Addendum No. 1

Bid Opportunity: 7159-RW-22 – Smithson PS Office and HVAC Upgrades.

Closing Date: Monday, March 14th, 2022 2:00 PM

16 Interior Elevation - New Glazing West (Reception/Admin 101)
1 : 25

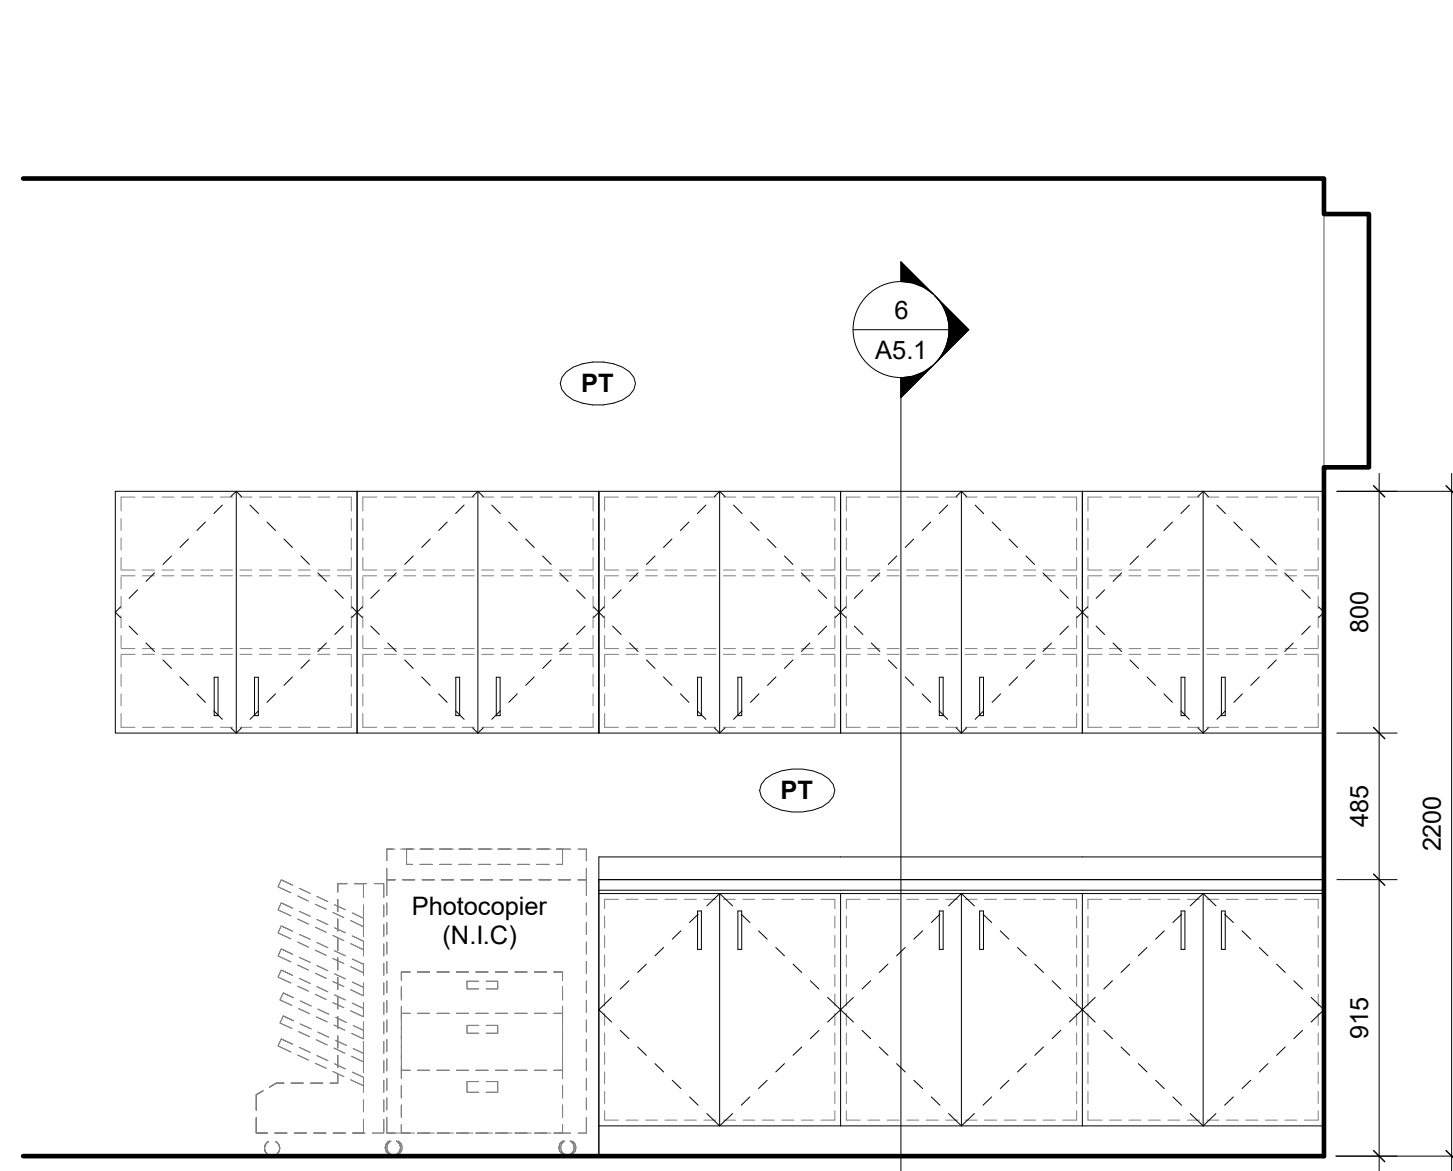
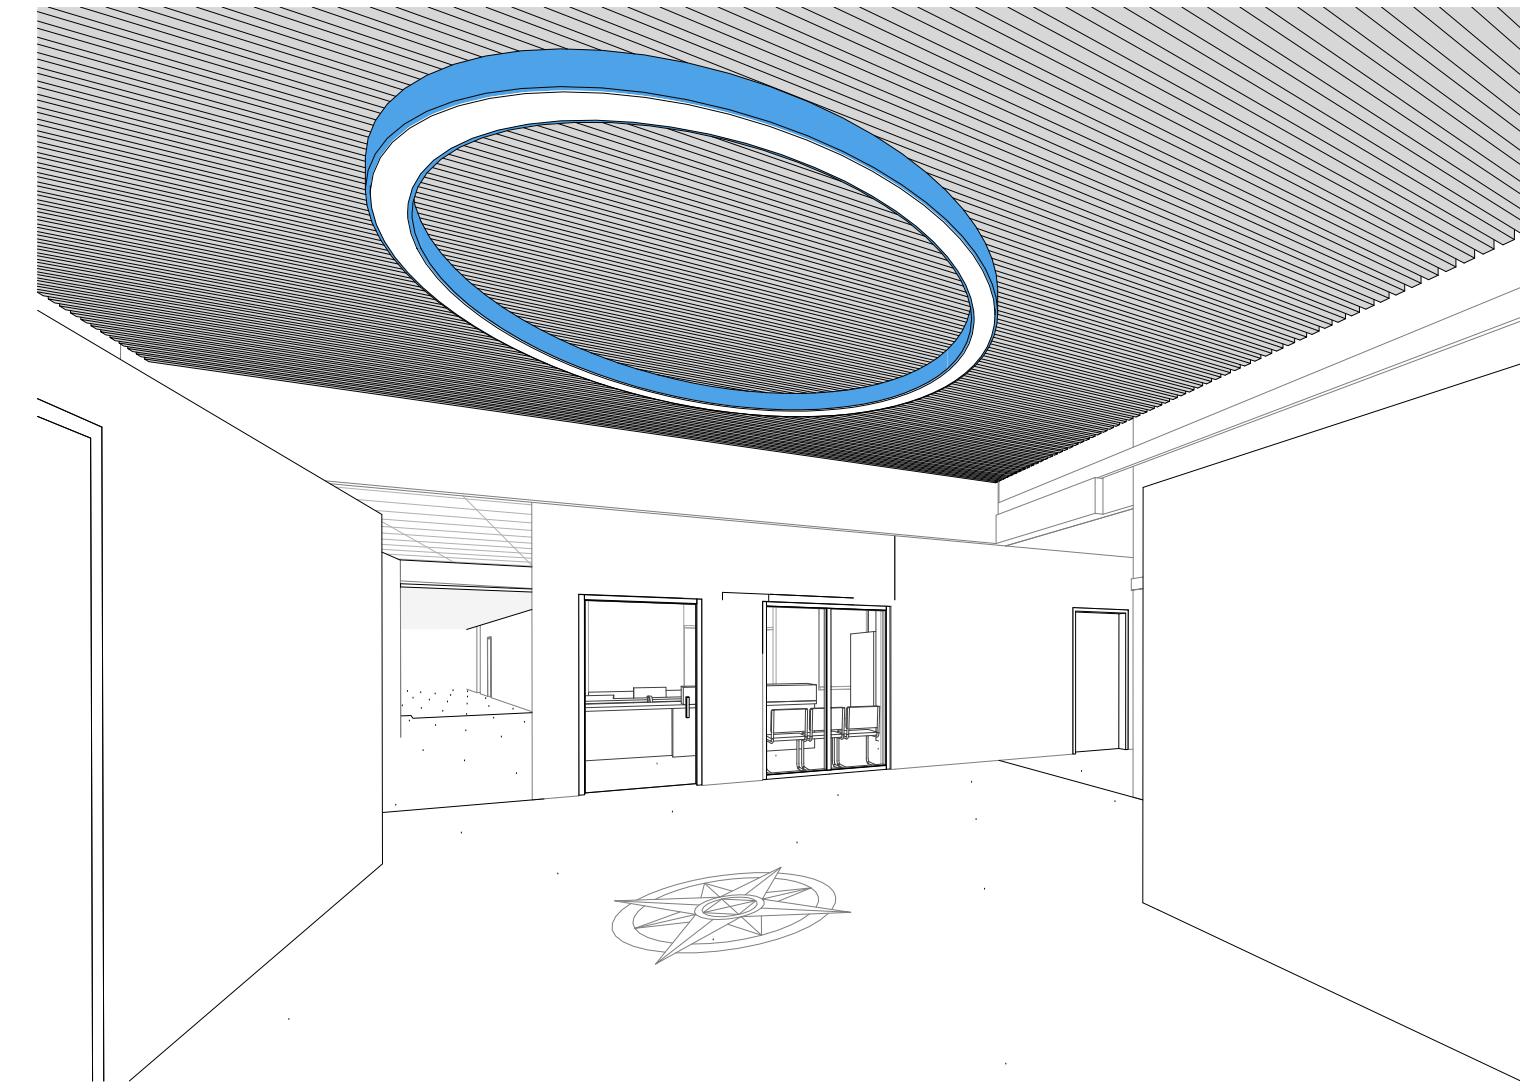
Refer to attached A4.0 Interior Elevations for Revised Detail 15 and 16.

Fill GWB PW1 between door and hollow metal screen up to underside of beam

Drawn By MS Scale 1/8"=1'-0"
 Designed By MS Date November 26, 2020
 Project Number **B20-349.02A**
 Sheet Number Revision
M3 1

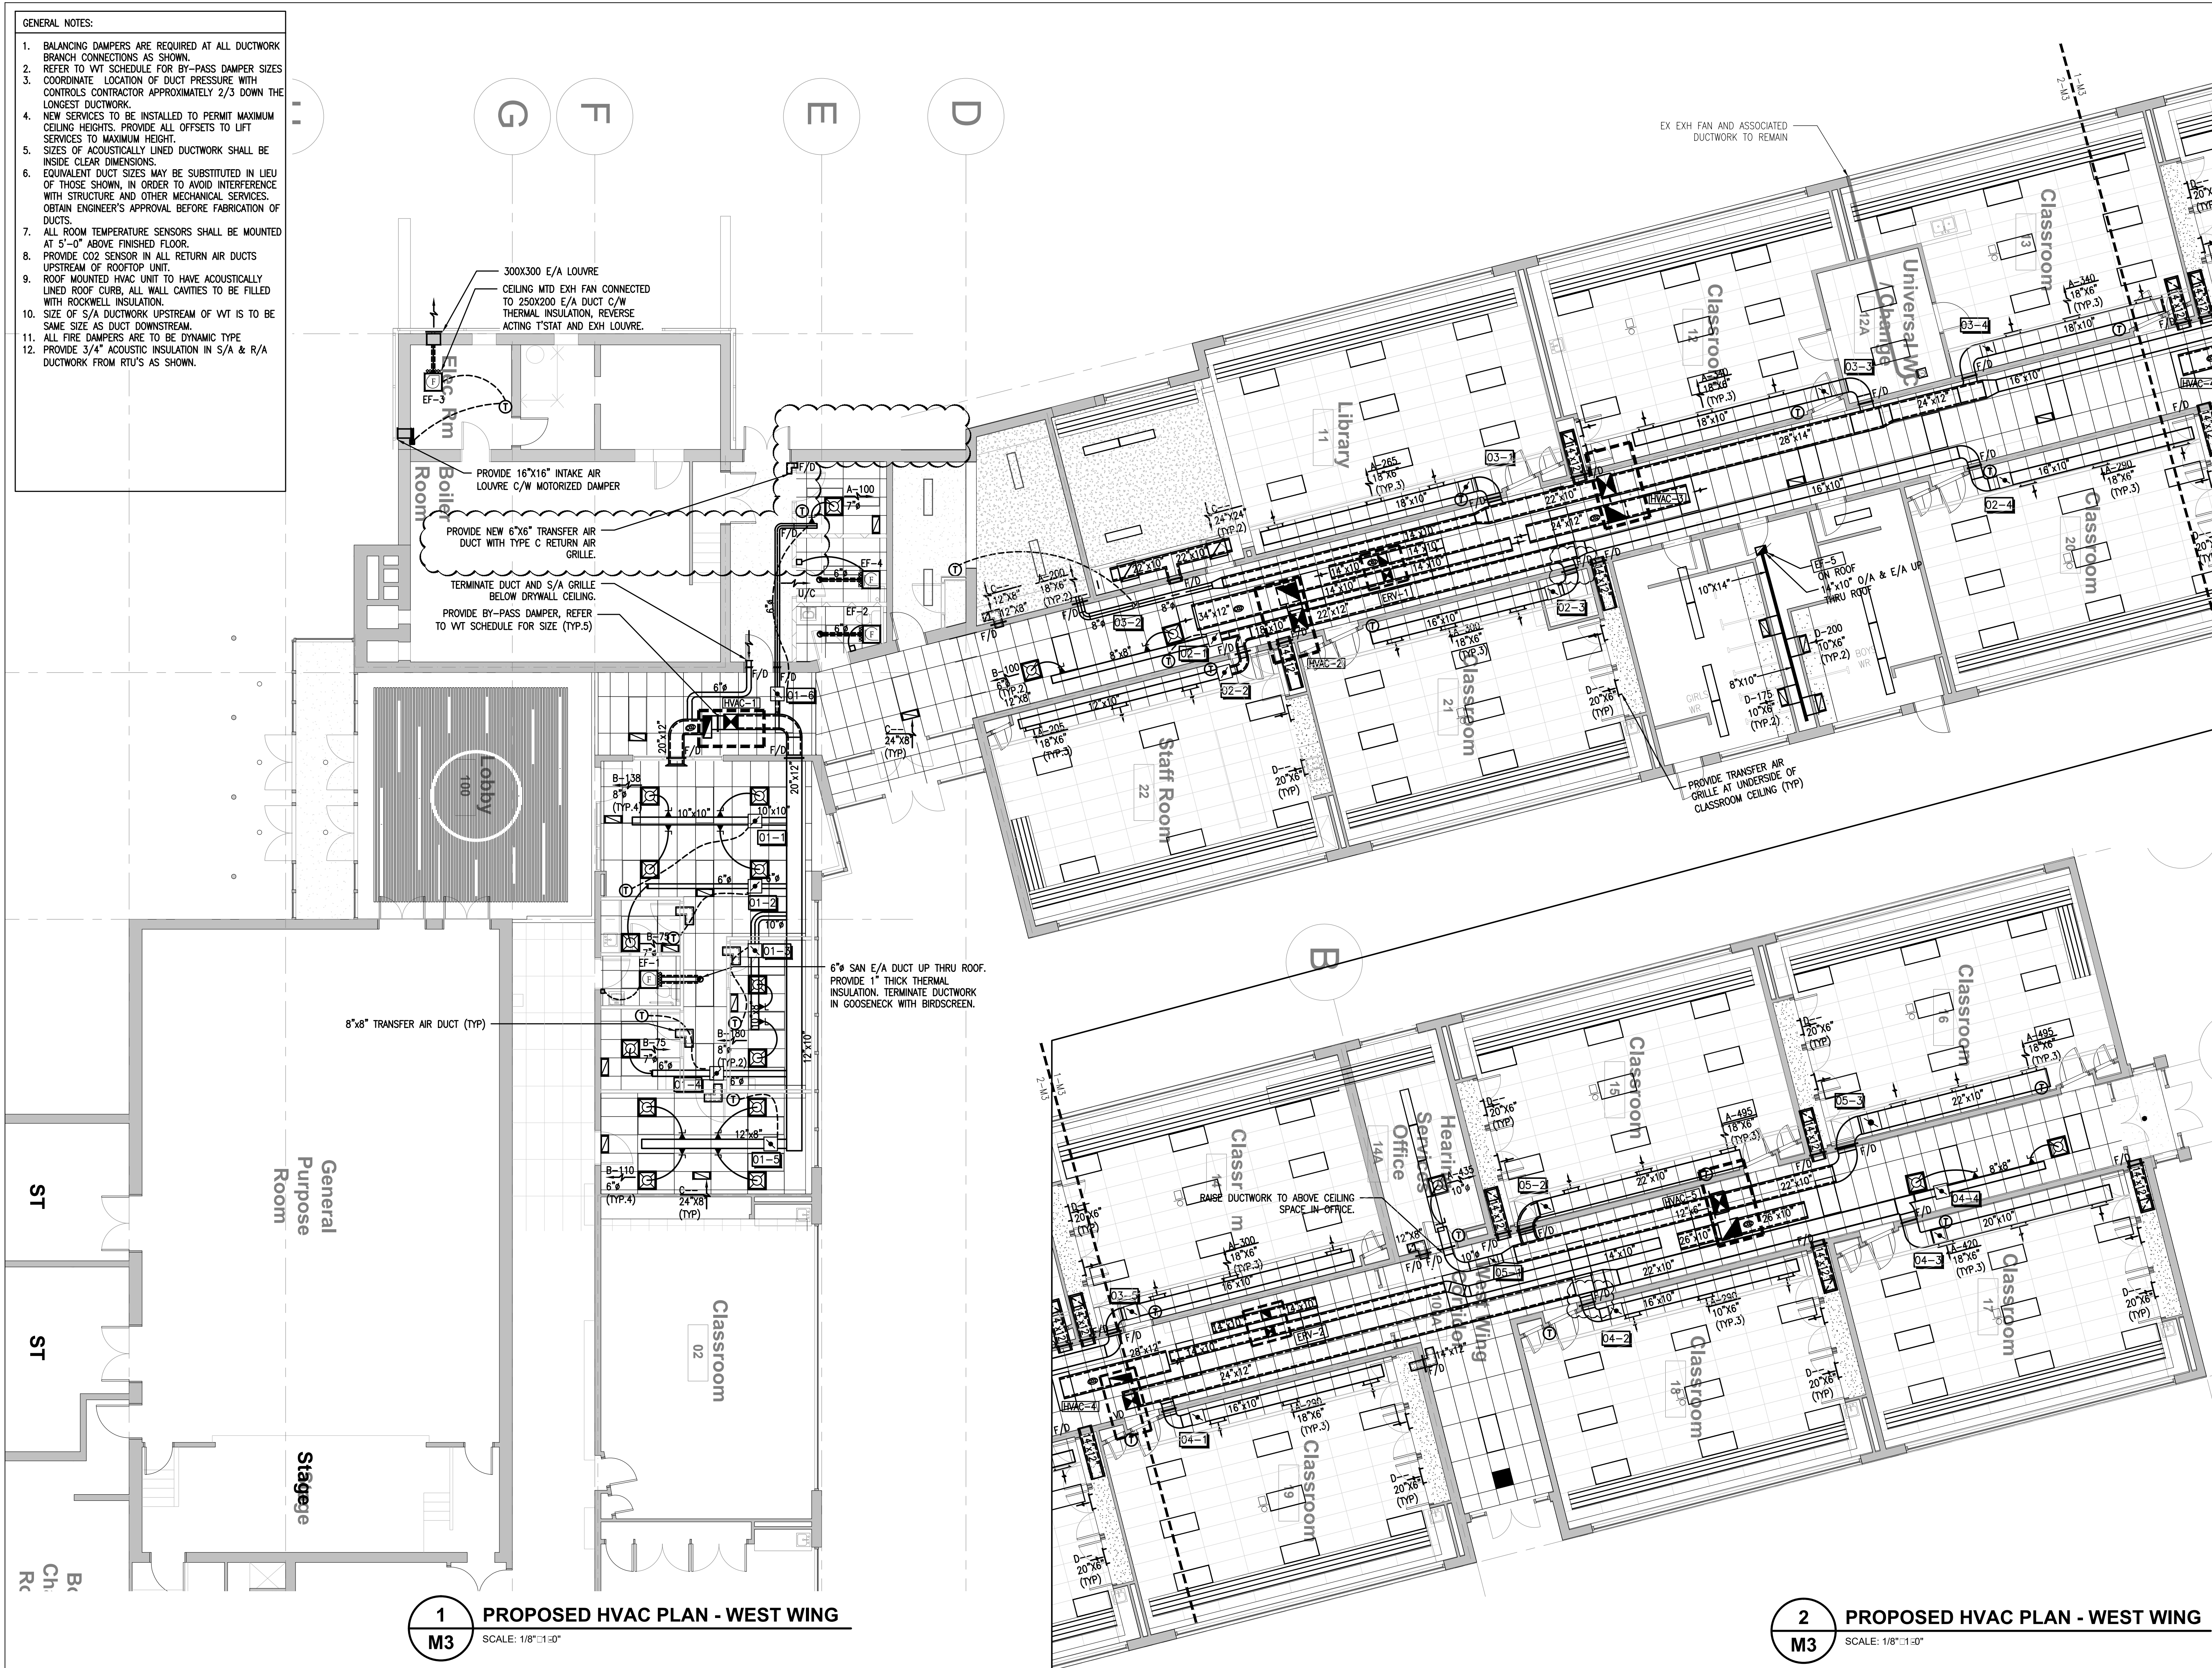
1. REFERENCE DRAWING M3 – PROPOSED HVAC PLANS – WEST WING (RE-ISSUED)

1. Install fire damper in supply ductwork serving Classroom 21 and 18.
2. Install a 6”x6” transfer air ductwork serving Janitor’s Office complete with fire damper
3. Provide a fire damper in 6” supply duct serving Janitors Offices
4. Refer to Dwg for details
